Knit Horizon Ltd.

Holding: 36/1,Block-E ,Boherarchala , Sreepur , Gazipur
(24.200399N,90.400936E)
28th December 2016

Observations

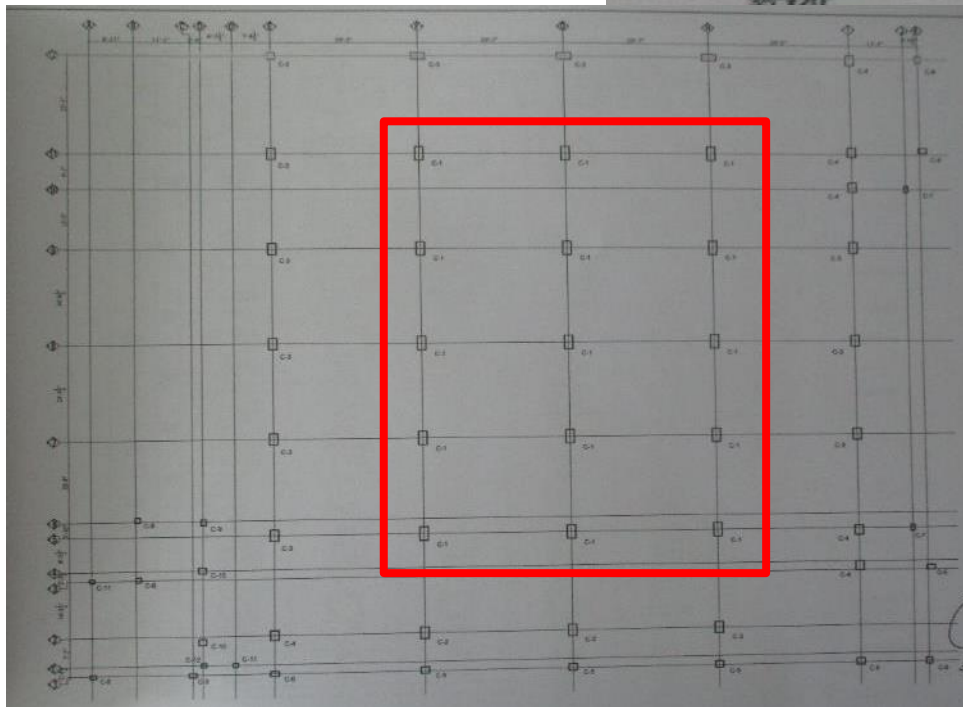
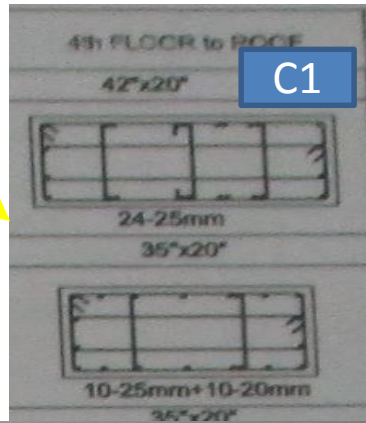
Rebar arrangement of C1 Column not match with column schedule. During inspection (17-25mm + 7 – 20mm) rod found instead of 24 – 25mm rod. (Checked on Roof)

C3

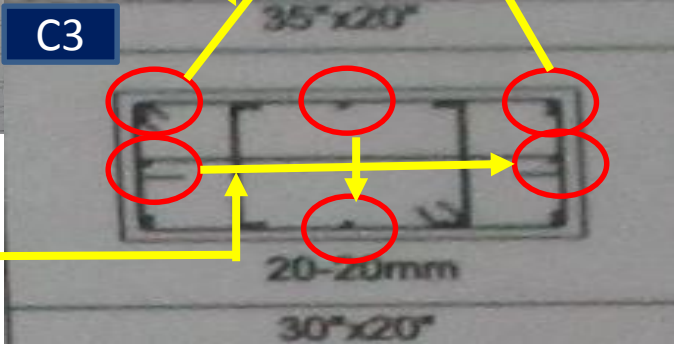
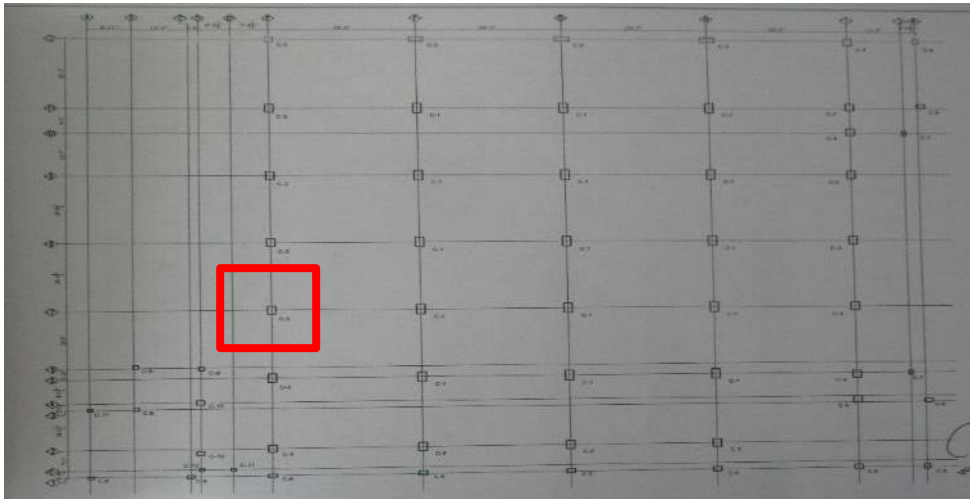
Rebar arrangement of C3 Column not match with column schedule at roof

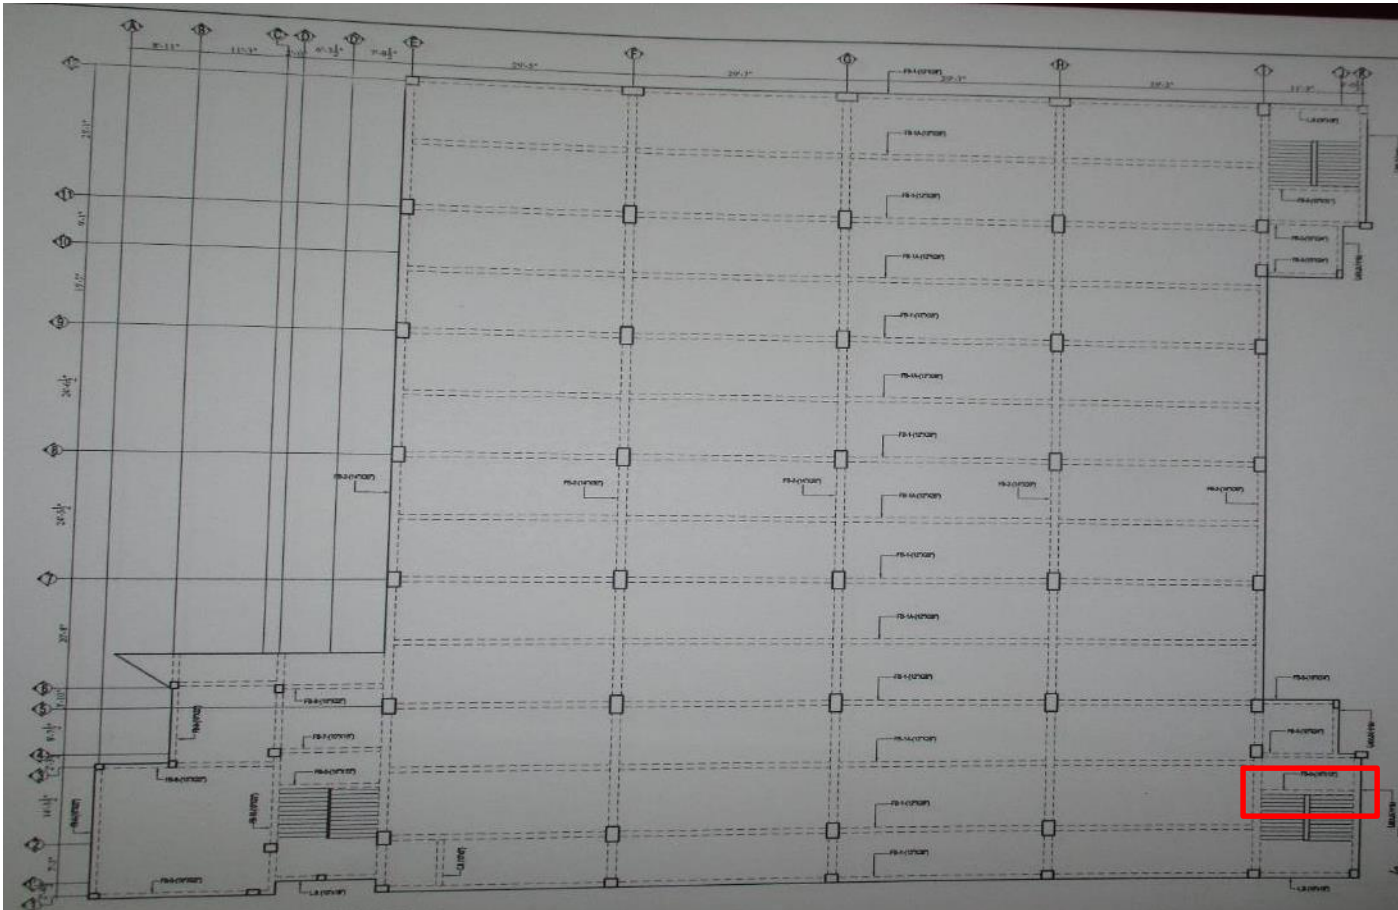
Stair Beam was not found on the highlighted portion on 1st and 2nd floor level

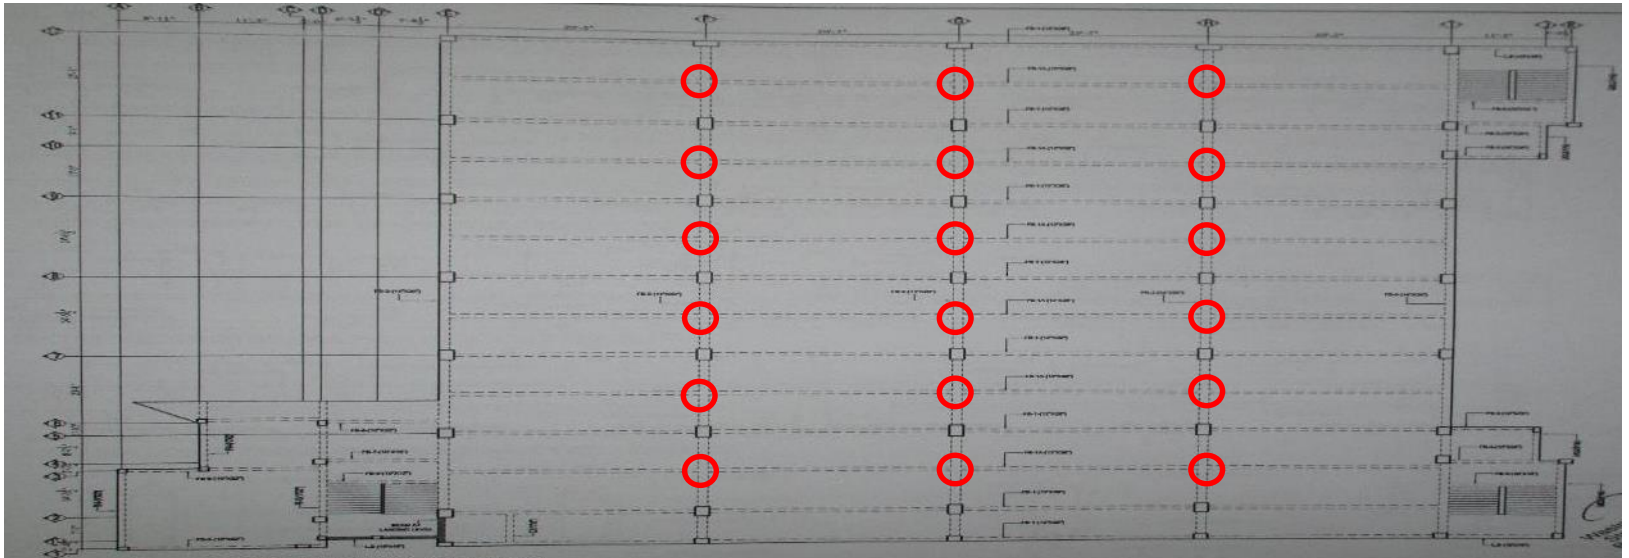
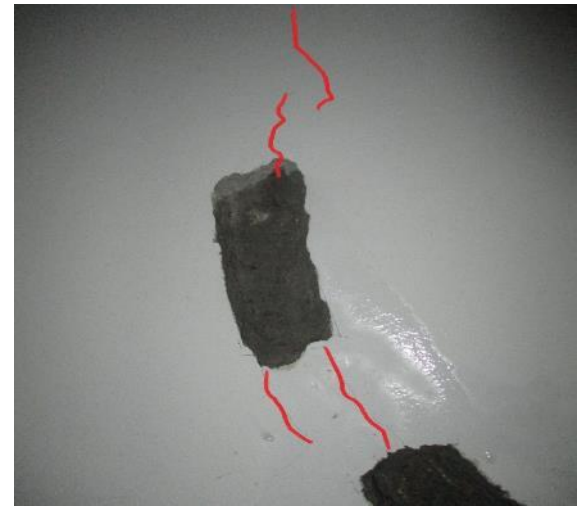
Cracks found on beam to beam joint on every floor above ground.

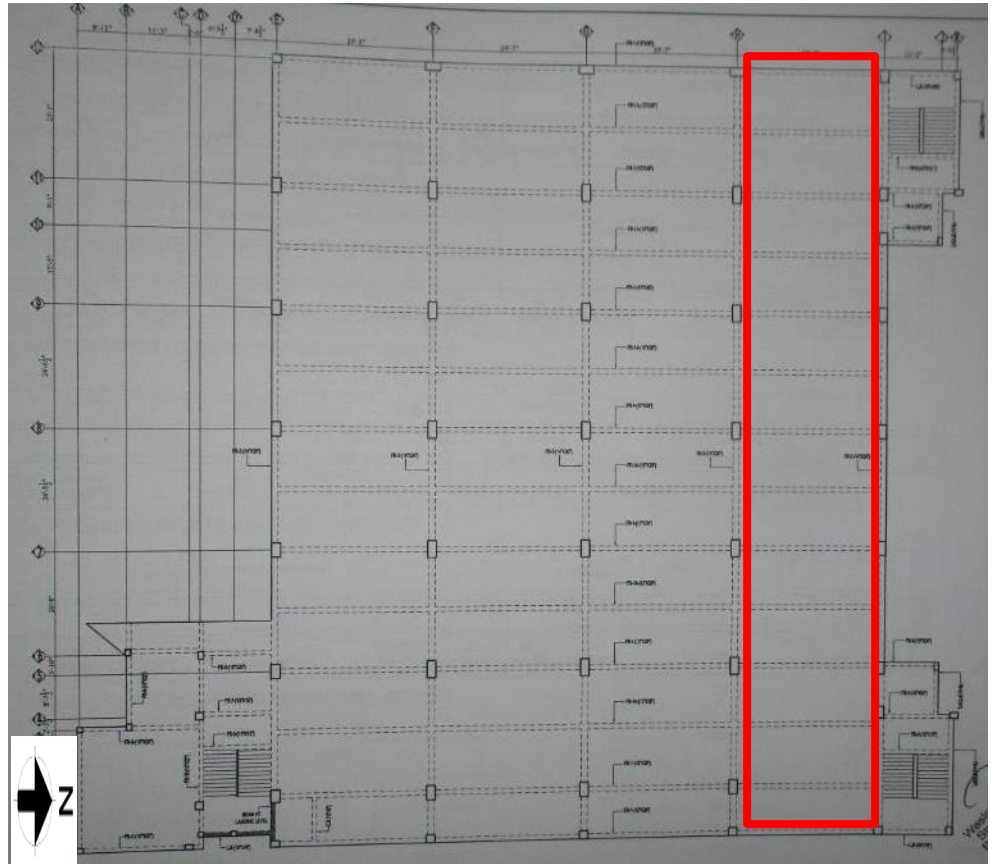
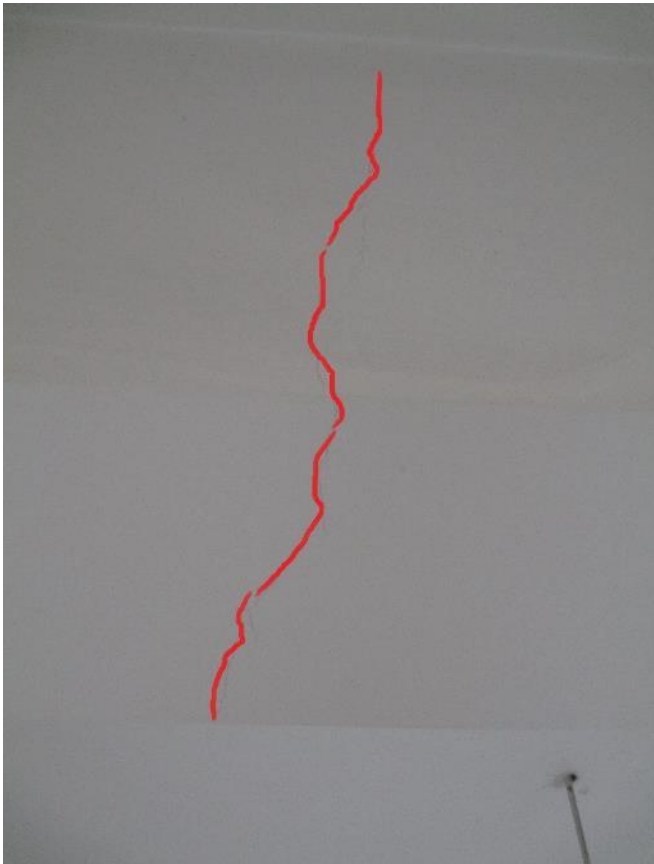
During inspection, cracking was found on mid span of beam of the highlighted bay on several floors.

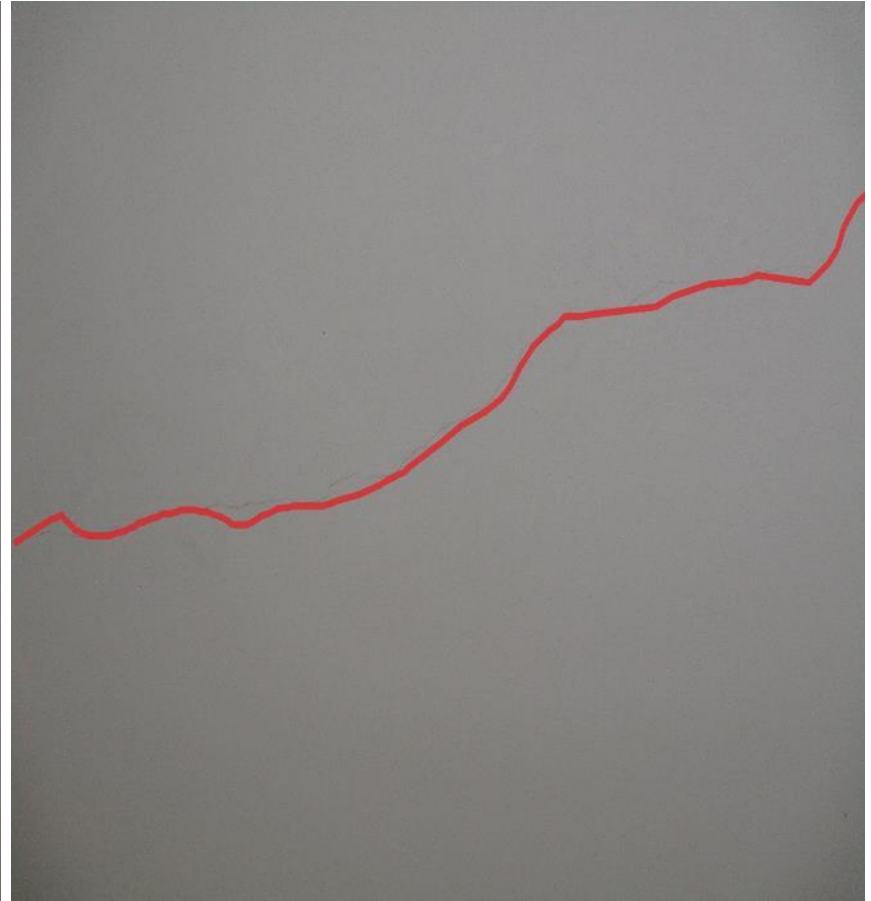
Cracking found on slabs on several panels of different floors.
